We thank all three reviewers for their constructive comments and suggestions. This manuscript will be much improved by their input. We have made changes to our manuscript. In the following responses, we use “**bold**” text for reviewer’s comments, “non-bold” text for our responses, and “*italic*” for changed text in the manuscript. Line # refers to that in the **marked-up** manuscript.

**This paper presents the results of a validation effort for ICESat-2 ice surface elevations in East Antarctica. The campaign was coordinated with the CHINARE Antarctic expedition from December 2019 to February 2020. The authors focused on an assessment of both the ATL03 (geolocated photons) and ATL06 (land ice elevations) along-track ICESat-2 Level 3a data products. The goal of this effort was to determine the ICESat-2 product vertical accuracy and precision using four different approaches.**

**Figure of the Fraunhofer diffraction pattern of the 6 cm diameter CCR ( $\lambda=532$  nm,  $H=500$  km, and  $d=6$  cm)**

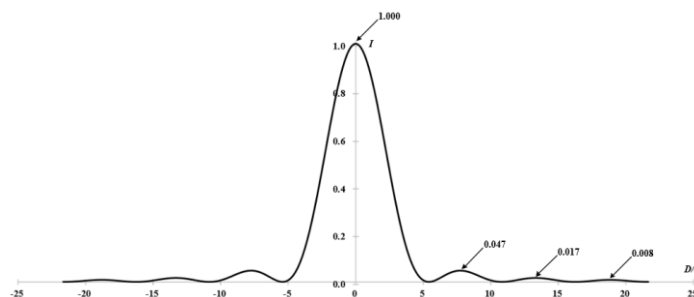
- **Why do the authors use 6 cm diameter CCRs for ICESat-2 when clearly for 532 nm that size optic would suffer from velocity aberration? Was this considered in the selection? Does that make a difference in the analysis if the returns are coming from the lobes of the diffraction pattern rather than the central disk?**

The central disc of our 6 cm aperture CCRs has a diameter of ~10.82 m in comparison to ~40.57 m of the ~8 mm diameter CCRs in Magruder et al. (2020), according to Chang et al. (1971). Here is the Fraunhofer diffraction pattern of our CCR:

With the larger CCR aperture, in addition to the smaller central disc diameter, the total signal level (for both central disc and lobes) is also increased. Thus, it makes signals from the lobes of the Fraunhofer diffraction

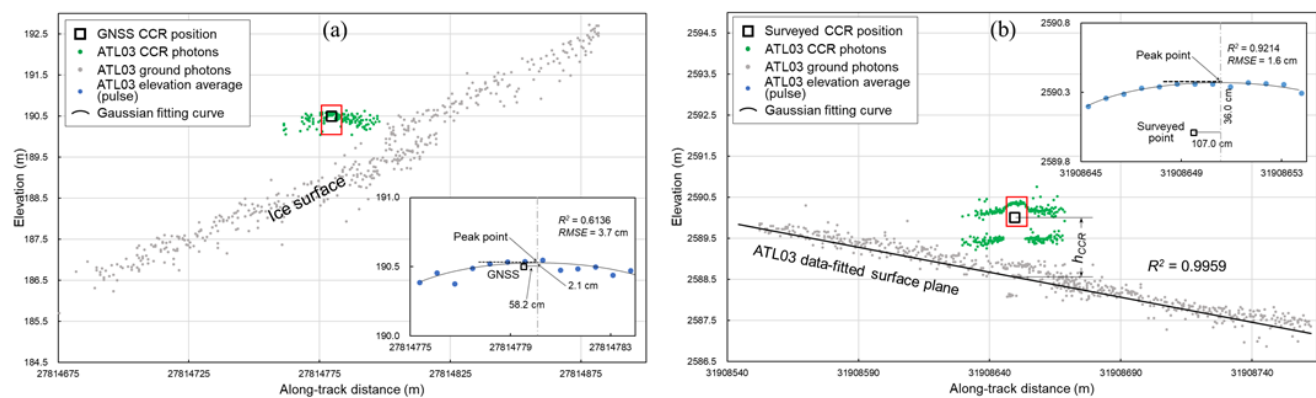
- **Figure 6 (c) Should this height be  $dh_{CCR}$ ? That was described as the distance between the top of the pole and the middle of the CCR, presumably not at the meter scale that is shown here?**

**Also, in this figure why is there a bulge in the CCR signature rather than a straight line as shown**

**in Figure 6 (a)? This seems as if the footprint illuminated multiple CCRs at different heights? This doesn't seem to be normal streak characteristics.**

Fig. 6 is improved to reflect the changes in the text:

(Fig. 6b): Sorry, it should be  $h_{CCR}$  (instead of  $dh_{CCR}$ ) that is the height between CCR center and ice surface (ATL03). It is changed in the figure. So, it is of meter scale.

(Line 420) “..... *On the other hand, a temporal distribution of energy within a pulse is approximately Gaussian (Smith et al., 2019); the received signals from the nadir CCR in the central disc are generally of a higher level (about 84% of the total energy) than those from the neighboring CCR in the outer lobes given atmospheric scattering and other optical losses (Magruder et al., 2020). This increased “signal-to-noise” ratio may have caused presence of the nadir CCR elevations only in the ~9 m central section along the photon streak in Fig. 6b (red rectangle). Therefore, by selecting photons inside the central window of the CCR streak it ensures that high quality photons from the nadir CCR in the central disc of the Fraunhofer diffraction pattern be used to estimate the elevation of the nadir CCR. The result is also validated by the nadir CCR position surveyed by using the high-precision GNSS RTK technique.*”

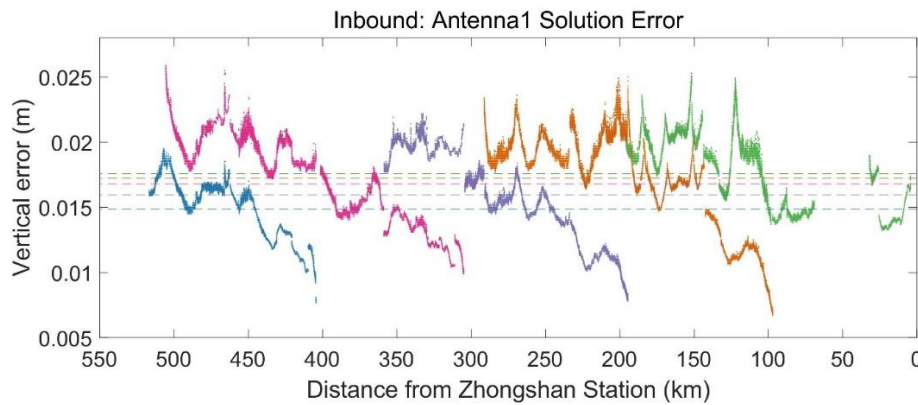
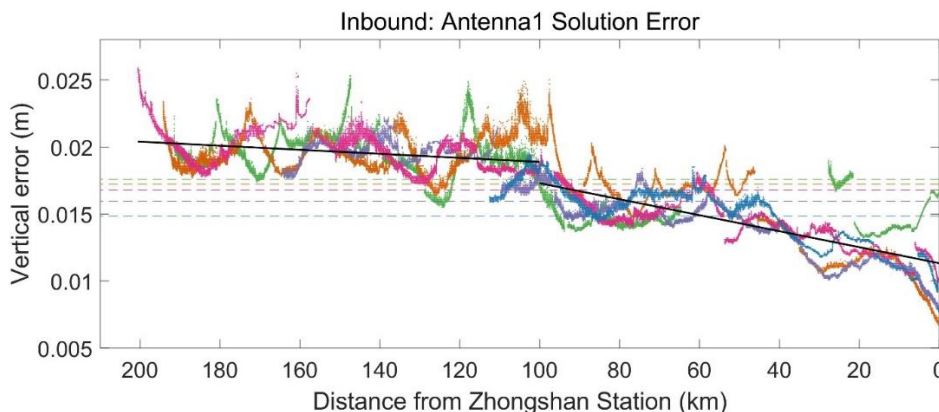
**3. (this comment refers to l.240) I appreciate that you checked the accuracy of the GNSS-profiles using crossover differences at intersections. However, I would suggest a few more analyses:**

**- If I understand you correctly, you separate your total profile into shorter sections according to the distance to the base stations and post-process each section with this base station as reference. It would be very interesting to have some overlap in the processing of these the sections. Hence, at the transition from one section to the next one, you could process some measurements with both base station and compare the results.**

We plot the internal precision profiles of each ~200 km inbound segments in the following figure (colors do not have a specific meaning). They show that there seems to have a linear trend of decreased precision as distance from a base station increases. The extended segments from ~100 km to ~200 km generally have greater vertical errors than the first half. Overall, the profiles of the flat inland interior (beyond ~100 km from Zhongshan Station) showed better performance (particularly in their first ~100 km).

We then moved each profile to start from the same origin in the following figure to examine the internal precision trend vs. distance controlled by a single base station. The linear trend is clear. Thus, we use a linear function  $y = k \cdot x + b$  to model the relationship between the internal precision  $y$  and distance from coast  $x$ . We have three cases: Traverse (0 km – 200 km), Segment 1 (0 km – 100 km), and Segment 2 (100 km – 200 km). The average  $\pm$  standard deviation of the internal precisions for the three cases are  $1.6 \pm 0.3$  cm,  $1.4 \pm 0.2$  cm, and  $1.9 \pm 0.2$  cm, respectively.

Within the first ~100 km (Segment 1) errors increase at a steeper rate of 0.6 cm per 100 km and reach up to

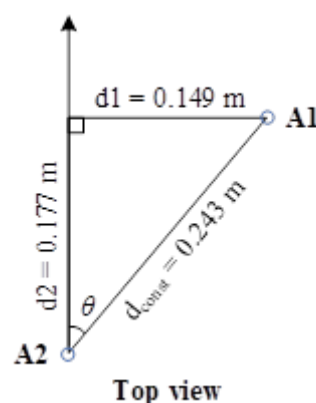
**- Moreover, referring to I.139 you have two antennas. Are they installed on the same PistenBully? If yes, are there any systematic offsets between them and what is the noise? If no, did you check crossovers between the two PistenBullys?**

Antenna 1 and Antenna 2 are installed on the roof of Pistenbully Polar300 (one vehicle) with a fixed offset (24.3 cm as measured by a steel tape).

(Line 100) The configuration was designed to have a check of GNSS observations for the hard baseline. However, as stated now in the **2.2 GNSS Data** subsection: “..... Antenna 1 served as the main GNSS receiver, while Antenna 2 also provided location data for an ice penetrating radar (IPR) mounted on the snowcat during the inbound trip. Due to incidental battery problems and inter-equipment interferences between Antenna 2 and IPR, the GNSS rover surveying was carried out by a combination of two receivers.....”, the data rate for Antenna 2 was set as 10 Hz to match that of the radar device, compared 1 Hz for Antenna 1. That caused

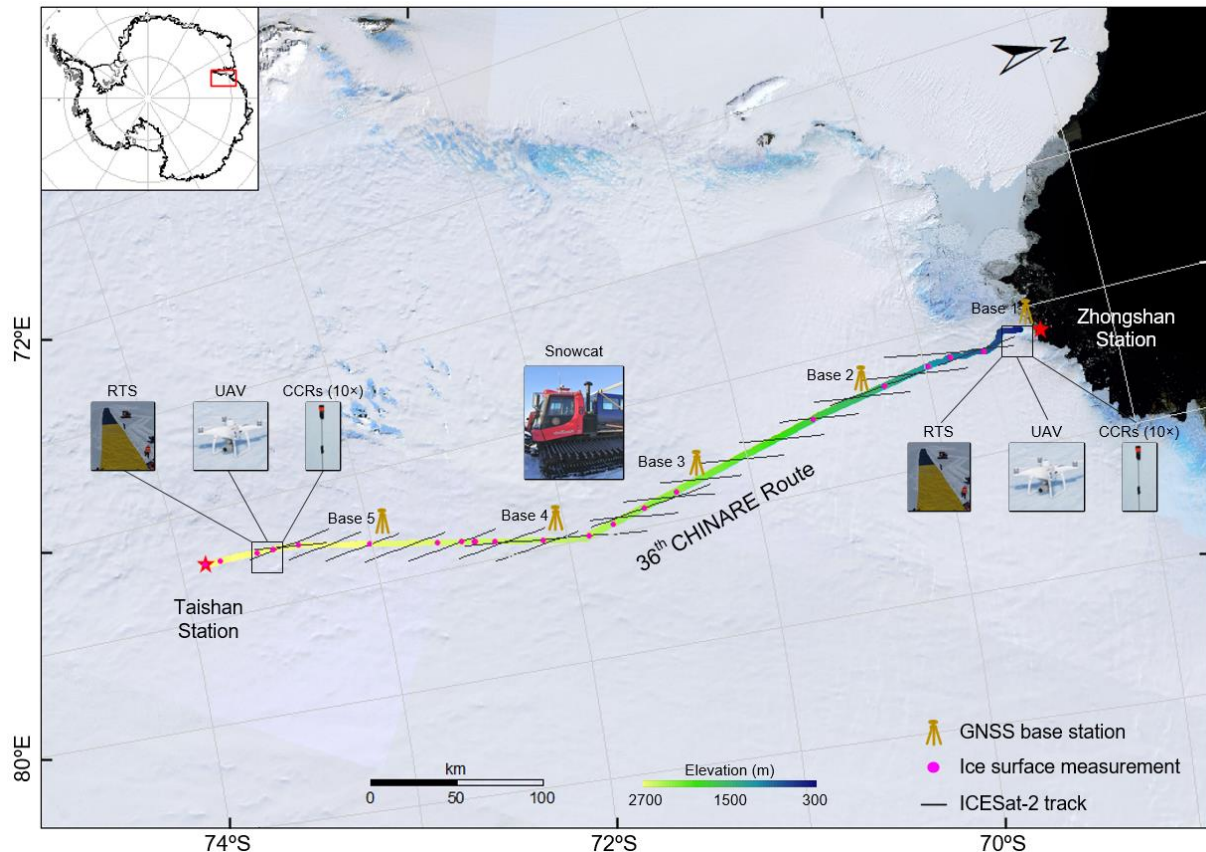
**Fig.1: In this context, no measurements have been conducted at Great Wall Station. It is fair to mention the original plans in the text but I suggest to remove the inset from Fig.1.**

(Figure 1) The Great Wall Station is now removed in the inset.

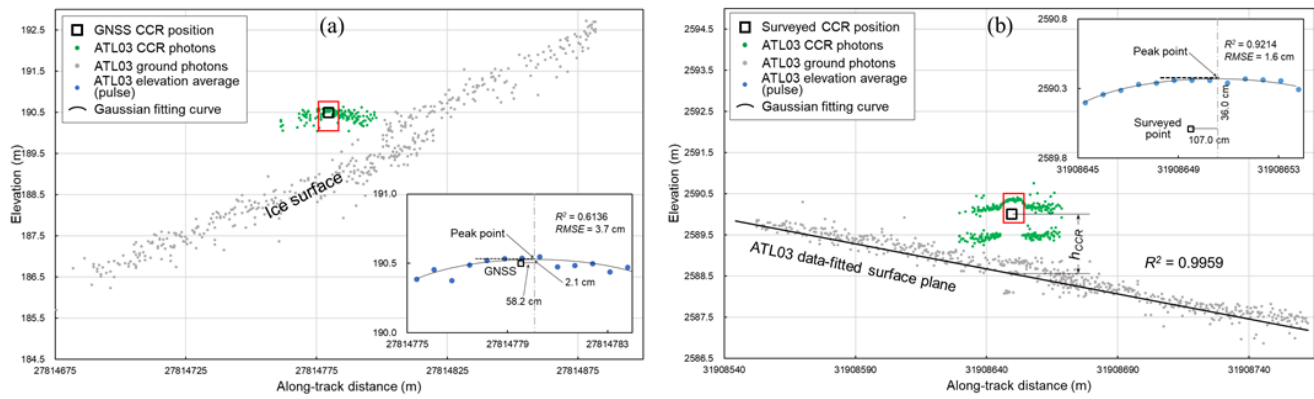
**I.210: I would have expect that the CCR looks like a unique point reflector. Why does it show up as a curve with slightly lower elevations on the sides?**

Fig. 6 is improved to reflect the changes in the text:

**Figure of elevation differences at crossovers between ICESat-2 (ATL06) tracks and the GNSS traverse with red dots for inbound and blue dots for outbound pairs, and diamonds for  $h_2$  measurement locations.**

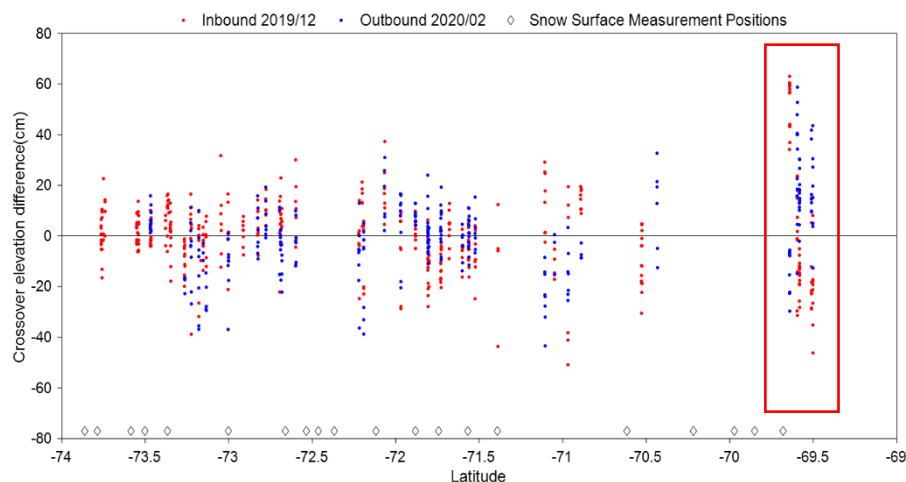
**I.266ff:** You state that the standard deviation of the  $h_2$  measurements is  $\sim 3$ cm and this variation is mainly attributed to the microtopography and firn density changes. However, the effect of microtopography will apply immediately when you move a few meters. Systematic variations in density should be largely accounted for by the IDW interpolation. So in my opinion, these effects alone cannot be responsible for these larger differences when using the full profile. Using only data in a 2 km vicinity of the  $h_2$  measurements reduces the usable crossovers dramatically. So, before reducing the amount of data so drastically, I suggest to do a few more analysis on these larger difference. Did you do any outlier checks before calculating these standard deviations? A few outliers can have a large effect on stddev. Or is there a specific spatial pattern (maybe in the region around 71S, which is the largest gap between  $h_2$ -measurements)?

That is a good suggestion, thanks. The following plot of ATL06 – GNSS elevation differences (red and blue dots) does show that there is a segment of traverse in the red rectangle where outliers occurred. So, we checked the field measurement notes that show that the closest three  $h_2$  measurements (diamonds on the bottom) were erroneously measured to the bottom of wheel-chain prints, while all other  $h_2$  values were measured to the ice surface. They were the first three ice surface measurements of the traverse.

We performed the following experiments to test the impact of the outliers: a) including just each one of the three  $h_2$  outliers (along with rest), and b) including all three  $h_2$  outliers (along with rest; this had the lower precision result in the appendix of the previous manuscript). No distance limit to  $h_2$  locations is applied. All results of Experiment a) are similar to that of Case b). Thus, we had to give up all three  $h_2$  measurements (outliers), correspondingly also the ATL06 – GNSS pairs in the red rectangle in the above figure since they

**Figure 1. ICESat-2 validation campaign based on coordinated multi-sensor ground observations along the 36th CHINARE route. The Landsat image mosaic of Antarctica (Bindschadler et al., 2008) is used as background.**

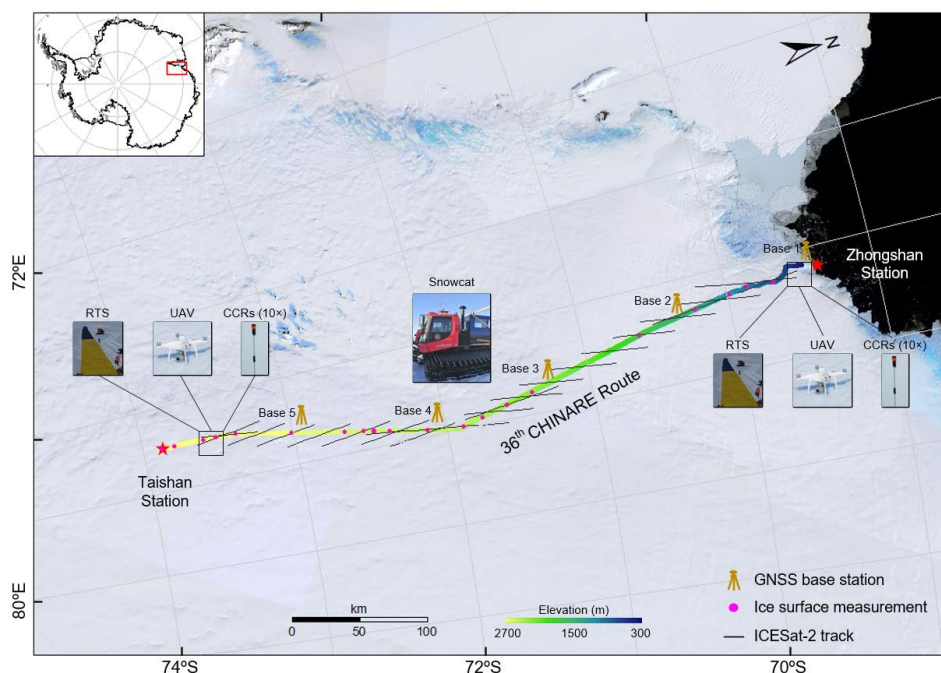
**Figure 1 Where is the inset map of Great Wall Station located? Does the inset need to be included if the station was not used as part of the campaign?**

We deleted “Great Wall Station” in the inset.

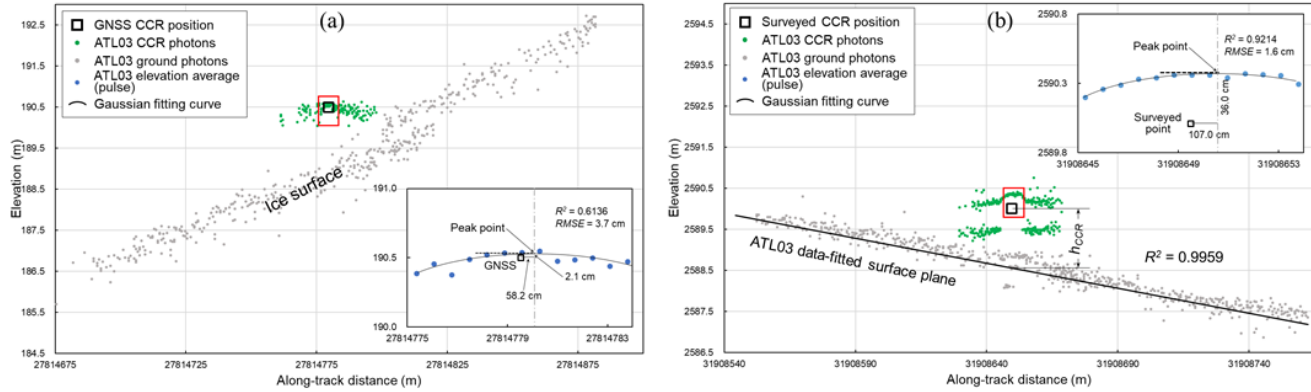
**Figure 6 Is there a way of combining the plots for the same region to not repeat information? Maybe at some middle level of zoom?**

We modified Figure 6 accordingly (see Fig. 6 above).

**Fig. AC3-1**

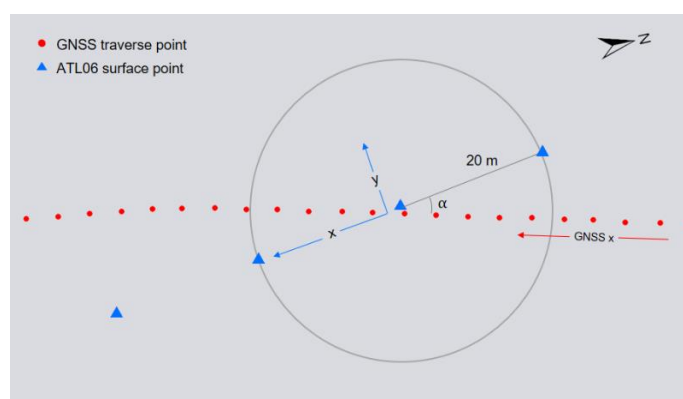
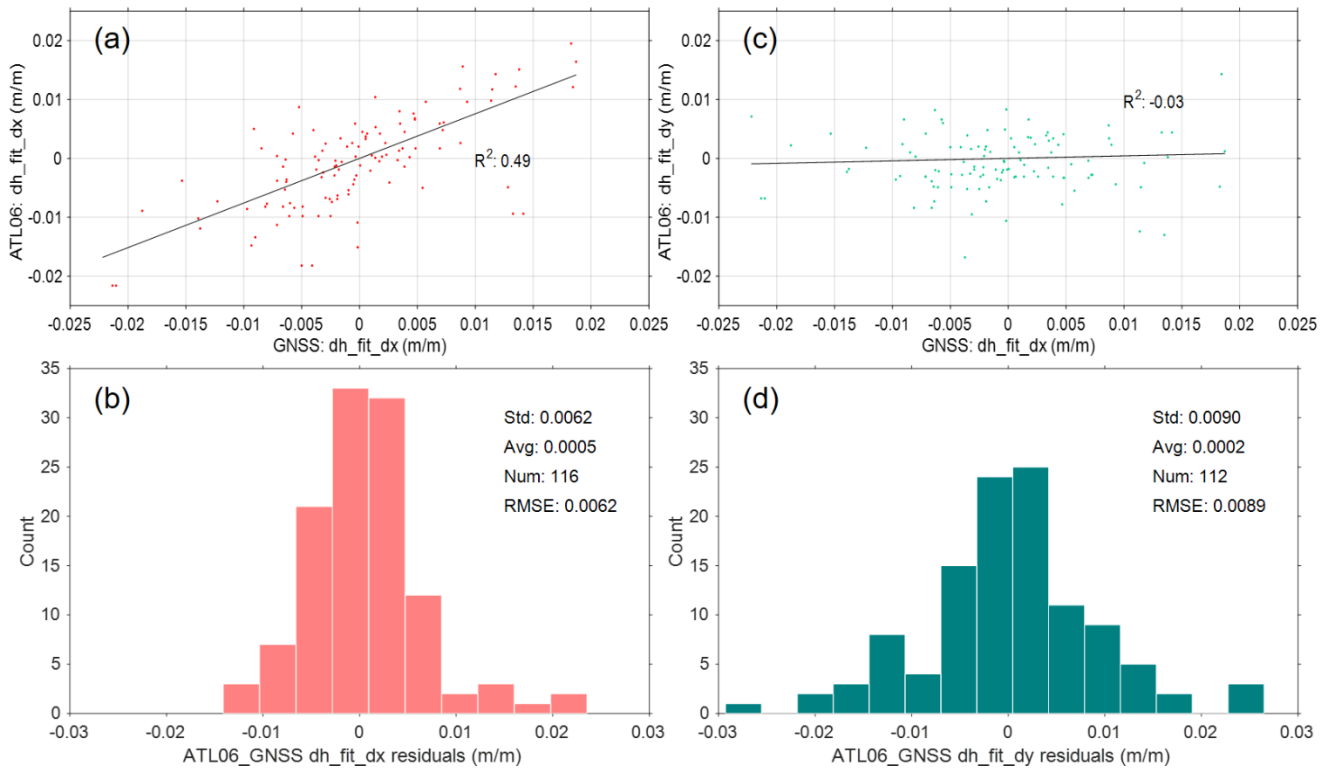
**Page 9, Lines 187-189 As this campaign includes multiple different terrains, was slope considered when comparing with the ATL06 measurements? i.e. along-track slope is estimated when calculating the average surface height in ATL06. Would your ground measurements also provide a metric for the along-track and across-track slopes estimated by ATL06?**

Thanks for bringing this up. Our data can only provide along - GNSS track slopes. We computed the GNSS slopes at each GNSS – ICESat-2 (ATL06) intersections using GNSS points within a 20 m radius window, so the slope scale matches that of the 40 m ATL06 segments. The GNSS slopes are the result of a least-squares linear fit to the GNSS points. In addition, we also calculated the intersection angle  $\alpha$  (Fig. AC3-1)

We generated the following figures to compare the slopes between GNSS (along - GNSS track) and ATL06 (along - and cross - track) results. Fig. AC3-2a shows that the GNSS slopes are relatively consistent with the ATL06 along - track slopes ( $R^2 = 0.49$ ); the RMSE between the two sets of slopes is 0.0062 ( $0.36^\circ$ ). In contrast, the comparison with the ATL06 across - track slopes resulted in a low  $R^2$  of -0.03 and RMSE of 0.0089 ( $0.51^\circ$ ) (Fig. AC3-2c). Their histograms are presented in Figs. AC3-2b and AC3-2d. Note that we removed four ATL06 slopes because their error flags  $dh\_fit\_dy$  are too large (in the order of  $3.4e+38$ ). Considering that the intersection angles ( $\alpha$ ) are mostly within  $30^\circ$ , the ATL06 tracks are roughly aligned with the GNSS tracks. Therefore, the GNSS slopes are also closer to the ATL06 along - track slopes.

We performed a preliminary analysis of differences between the GNSS and ICESat-2 elevations vs. the intersection angle  $\alpha$  at the crossovers. We did find some large elevation differences associated with increased  $\alpha$ . Furthermore, a significant correlation between the elevation differences and along - track or cross – track slopes is not present (very preliminary).

Fig. AC3-3

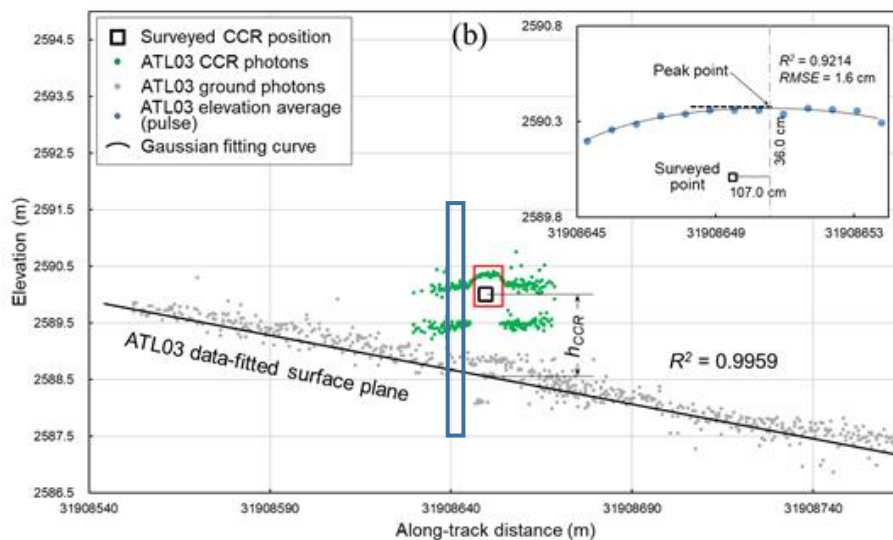
**Page 14, Lines 309–310 The weak beam also returns to 1/4th the number of detectors (4 instead of 16) and has different thresholds for saturation in the ATL03 algorithm.**

We may not have got your question quite right. Here is our try. The strong beams recorded 9.0 and 7.0 photons per pulse in average at the two sites (see table below): not saturated and no impact of CCR (90 m away). However, the weak beam, for example at Taishan Station, returned 9.7 photons per pulse in average. We further examined all 7 pulses over the 5 m - wide RTS sheet. Their photon counts per pulse are: 10, 12, 10, 9, 8, 9, 10. Correspondingly we can see three layers of returned photons (within the blue rectangle in AC3-3) from a) nadir CCR (top), b) neighboring CCR (middle) and ice surface (bottom), respectively. Since the travel times of these photons from different layers are different, many photons hit the four weak beam detectors at different times and thus, “managed” to be recorded by ATLAS between different dead times of the detectors. We think that it is how the high count-numbers per pulse (9.7 average) came about: saturated, but accepted and recorded by ATLAS.
